UNITED STATES PATENT AND TRADEMARK OFFICE

APPLICATION NO.	FILING DATE	FIRST NAMED INVENTOR	ATTORNEY DOCKET NO.	CONFIRMATION NO.
10/537,812	06/07/2005	Markus Egerter	028987.55877US	5467

Office Action Summary

ATTACHMENT 1

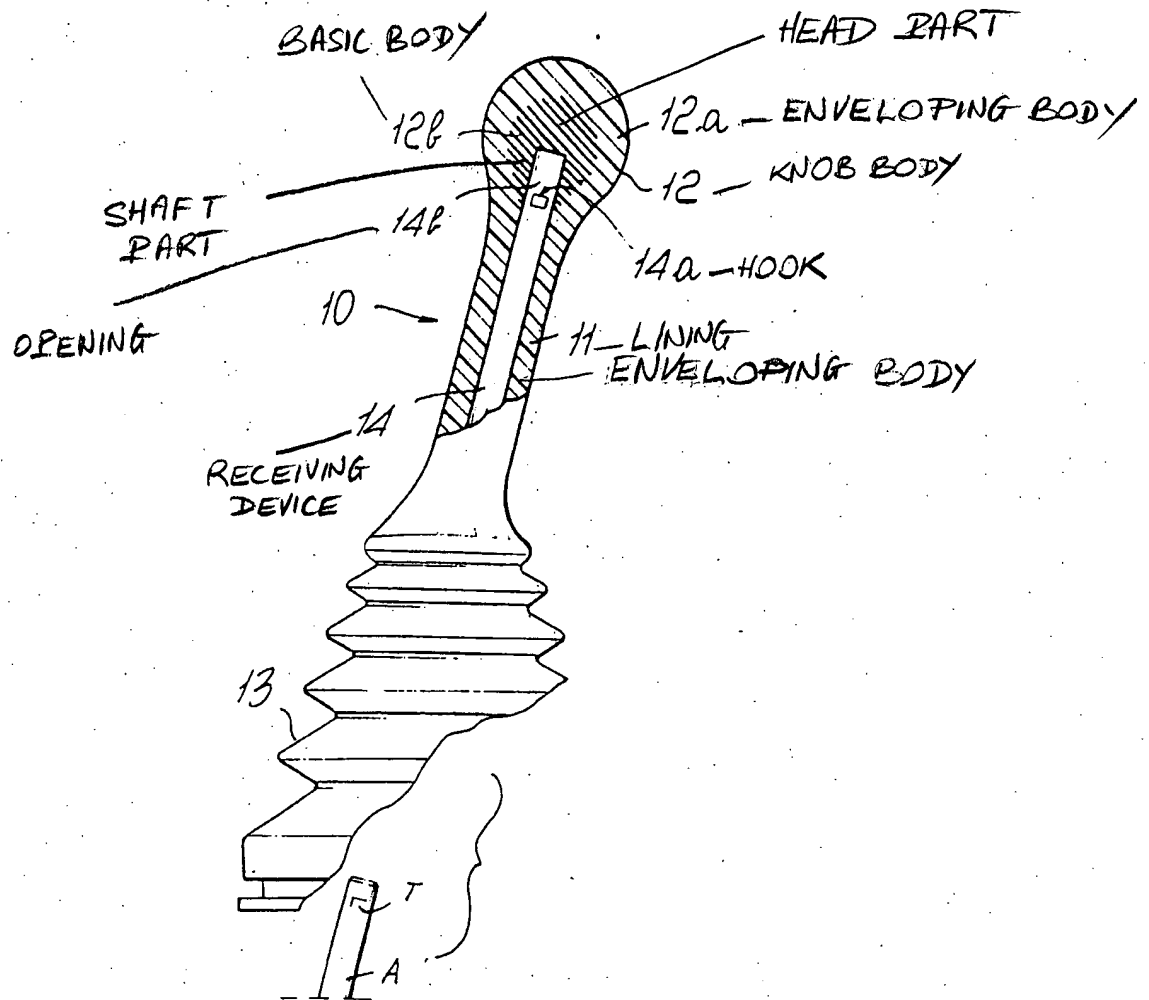
Regarding claim 14, the knob body 12 has a basic body 12b with a shaft part (see Attachment 1 hereinafter "Att. 1") and a head part (Att. 1) which are surrounded at least partially by an elastically constructed enveloping body 12a, 11 and wherein openings 14b are provided in a lateral surface of the shaft part (Att. 1) and are penetrated by sections of the enveloping body 12a, 11. *Ibid.* col. 2, lines 25-66 and claims 1-8.

Regarding claim 15, the openings 14b extend in axial and circumferential directions of the shaft part (Att. 1).

Regarding claims 17 and 26, the basic body 12b is of a hard plastic material and the enveloping body 12a, 11 is of an elastic thermoplastic synthetic material or polyurethane.

Regarding claims 18 and 28, a detent device for axially fixing the knob 10 on the control lever A is provided in the head part (Att. 1) of the basic body 12b.

Regarding claims 19 and 29, the detent device has several snap hooks 14a which engage in recesses T provided at the control lever A.
